***EXPEDITED***  
**MONTGOMERY COUNTY HISTORIC PRESERVATION COMMISSION**  
**STAFF REPORT**

<b>Address:</b>	17800 Bowie Mill Road, Derwood	<b>Meeting Date:</b>	2/16/2022
<b>Resource:</b>	(Master Plan Site #22/017-000A <i>Flint Hill II</i> )	<b>Report Date:</b>	2/9/2022
<b>Applicant:</b>	Leigh Dukatt	<b>Public Notice:</b>	2/2/2022
<b>Review:</b>	HAWP	<b>Tax Credit:</b>	No
<b>Permit Number:</b>	978966	<b>Staff:</b>	Michael Kyne
<b>PROPOSAL:</b> Installation of new telecommunications equipment

#### SILO ELEVATION

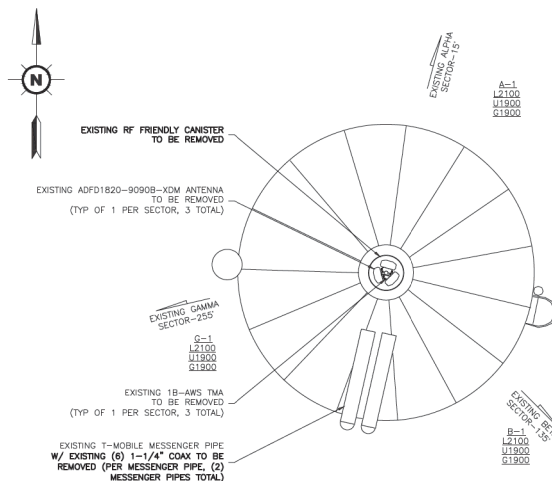
1. The proposed new RF Friendly Canister will be painted matte blue, with final review and approval delegated to staff.

The applicant proposes to modify the existing collocation telecommunications equipment on the non-contributing silo at the subject property. Specific work items, as revised, include:

- Removal of three existing antennas within an existing RF Friendly Canister at the top of the silo.
- Installation of three new antennas within a larger RF Friendly Canister at the top of the silo.
- Installation of nine new Remote Radio Units (RRUs).
- Removal of one existing equipment cabinet.
- Installation of one new equipment cabinet.
- Installation of one new battery cabinet.
- Installation of associated equipment.
